Response to Peer Review Comments on IWEM 3.0

Final

June 2015

Office of Resource Conservation and Recovery
Office of Solid Waste and Emergency Response
U.S. Environmental Protection Agency

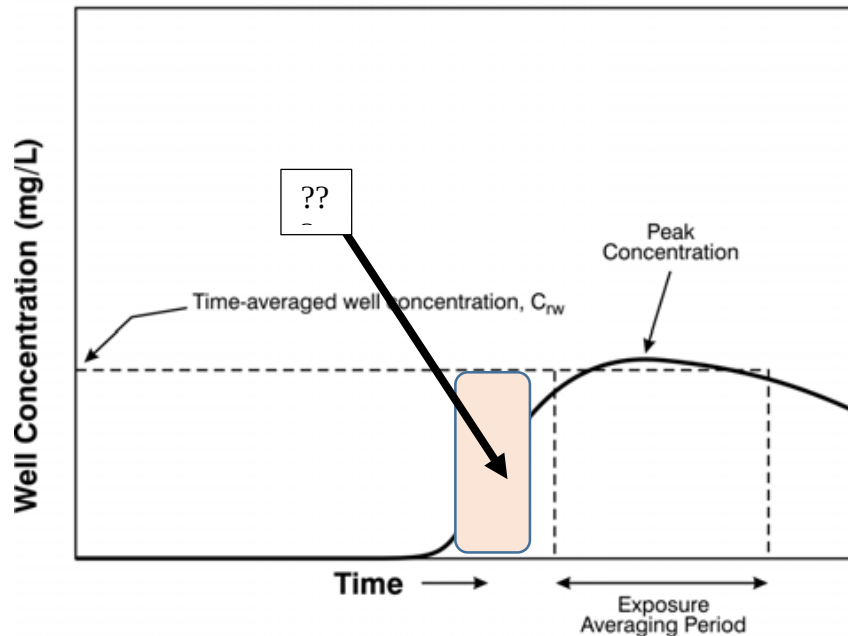
Page 4-1, Figure 4.1: What if the exposure averaging period belongs to another time range (see the pink domain below?) that only corresponds to (say) the raising part of the concentration breakthrough profile. Assume that the Trimester exposure period of a female is that period? Than what? Here the authors have described an ideal situation which is only one of the many possible cases. This is misleading and not correct.

Figure ES-1 Conceptual cross-section view of the subsurface system simulated by EPACMTP.

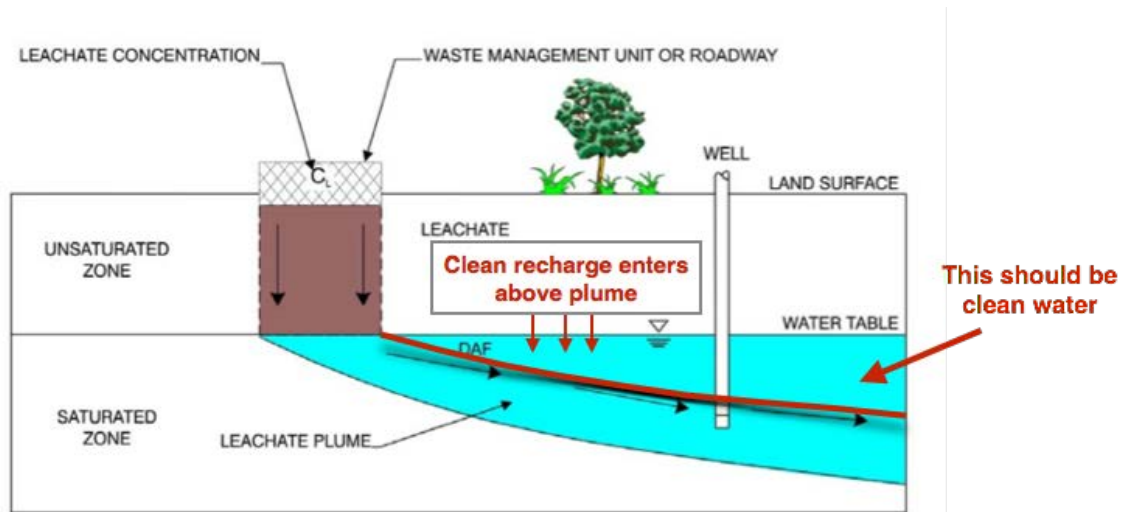
i. A set of figures (2-6 in Users Guide, ES-1, 2-3, 6-3 in the Technical Document) show a cross section through a plume emanating from a source. All of the figures show the contaminated water filling the area below the water table down to what appears to be a flow line emanating from the upstream edge of the source. Is this really what the simulated plumes look like? Does the model neglect clean recharge entering above the

plume and displacing the plume downward in the aquifer? This appears inconsistent with the description of recharge (section 6.3.3 in Technical Document). In the figure below, I show what the plume should look like. Contaminant plumes can pass beneath shallow well screens. The figures in the report appear to show that this can never happen.

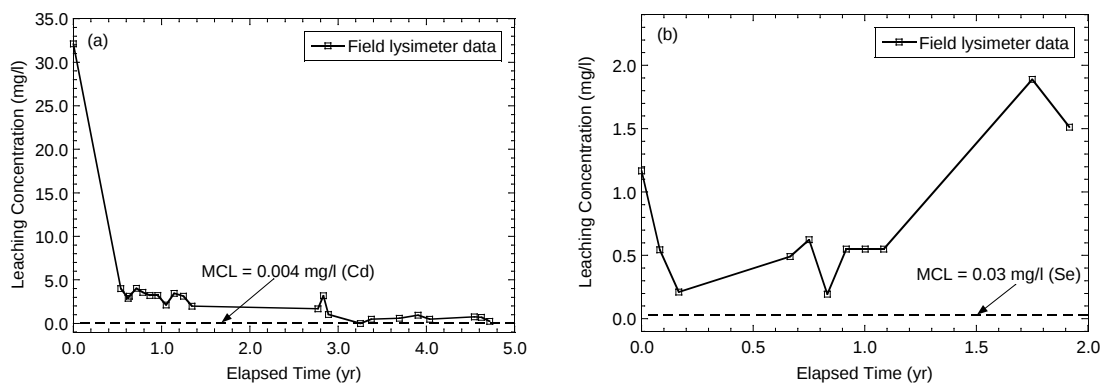
The pulse source is assumed based on screen-level analysis and a pulse source is assumed appropriate for metals. The reference for this critical assumption is missing from the technical document. Creek and Shackelford (1992) and Sauer et al. (2012) indicate that leaching patterns for coal combustion products (CCPs) and highway materials stabilized with CCPs generally can be grouped into two classes referred to as “first flush” and “lagged response” leaching. As shown in Fig. 1, the “first flush” pattern is characterized by monotonically decreasing concentrations as water percolates through the CCPs (Bin-Shafique et al. 2006), whereas the “lagged response” pattern is characterized by decreasing concentration followed by increasing concentration. First-flush leaching patterns from CCPs generally correspond to adsorption-controlled release and can be described mathematically by advection-dispersion-reaction equation with instantaneous, linear, and reversible sorption (Bin-Shafique et al. 2006). Lagged response leaching can be attributed to a variety of geochemical processes and generally cannot be described using a single mathematical function used in WiscLEACH (Li et al. 2006). WiscLEACH was originally developed by Li et al. (2006) for assessing potential groundwater impacts associated with fly ash stabilization in roadway construction. Based on three analytical solutions for the advection-dispersion-reaction process in the subsurface, Li et al. (2006) only evaluated the “first flush” leaching pattern in the two-dimension application of fly ash stabilization. WiscLEACH was revised to extend the capacity of original WiscLEACH from a two-dimensional application of fly ash stabilization to a three dimensional application of embankment and structural fills in roadway construction. The “lagged response ”and“ first flush leaching patterns are both included in this revised WiscLEACH (Li et al. 2011). The WiscLEACH has been used in several studies of industrial materials in embankments (Cetin et al. 2013ab, Li et al. 2014).

Since the contaminant flux is critical for the IWEM prediction, it is strongly suggested to consider either to provide more detailed documentation for the current assumption, or to adopt the “first flush” and “lagged response” leaching pattern instead of pulse source.

EPA Response: EPACMTP can model the leachate source as either continuous or finite sources. Furthermore, finite sources can be modeled as a pulse or depleting sources. Both of these modeling options are available for organic constituents. However, for metals that generally exhibit non-linear sorption behavior, the depleting source term modeling option cannot be used as the analytical solution for one-dimensional transport of a solute with non-linear sorption in EPACMTP requires the simplification of the leaching profile to a constant magnitude, finite pulse (i.e., a square pulse). These metals transport capability provided by EPACMTP and its accompanying assumptions have governed the development of the roadway formulation and the primary assumption that leachate profiles are conceptualized as square pulses. More detail discussions of the pulse and depleting leaching scenarios and the underlying assumptions can be found in *Section 2.2 of the EPACTMP Technical Background Document*. In addition, the text in Section C.2.1 of Appendix C of the *IWEM Technical Background Document* has also been updated to reflect how the assumptions of the transport module have influenced the formulation of the roadway module and to improve the presentation of the pulse assumptions and methodology.

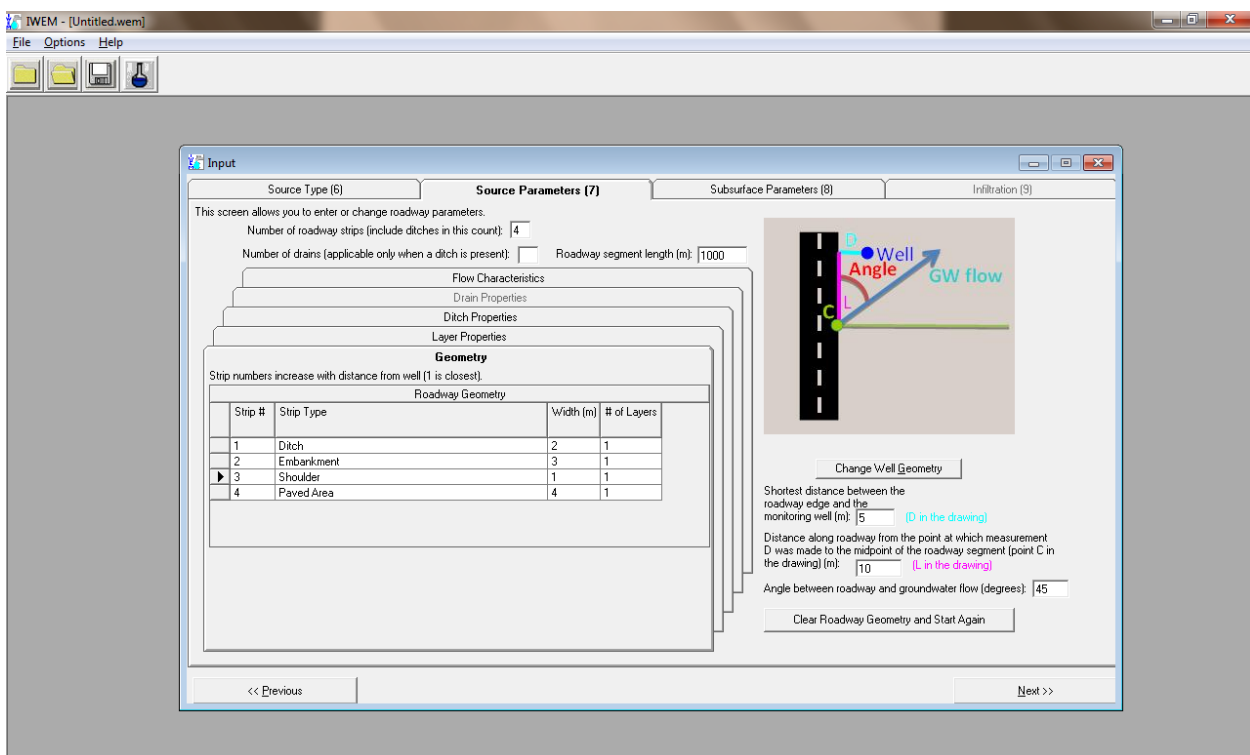
The IWEM interfaces are too old. When the user opens the IWEM, the icons of first screen are Windows 95 icons (shown in next Figure). Is it possible to change to at least Windows 7?

Figure 1: Example of a complex roadway from the report Appendix.

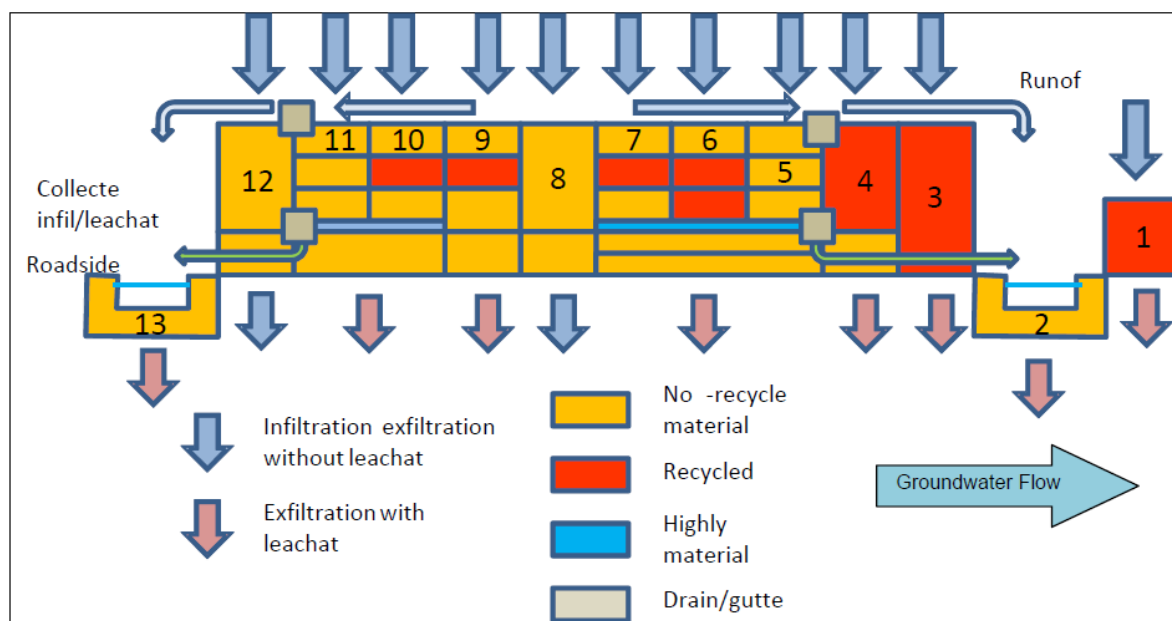
(c) Given the comments in 2 (b), I would like to comment on the development of equations for multiple road segments. If I interpret this short piece C.2.2.6 (Appendix pg. 20-22) correctly, the user needs a set of standalone tools that would take output from a sequence of IWEM runs and superimpose solutions and route mass along the ditch. I can expect that a typical user would not understand how to do such an analysis. If such a capability is desirable, then a simple worked example needs to be presented as a conceptual model, including steps explaining ditch routing and superposition of mass transport calculations.
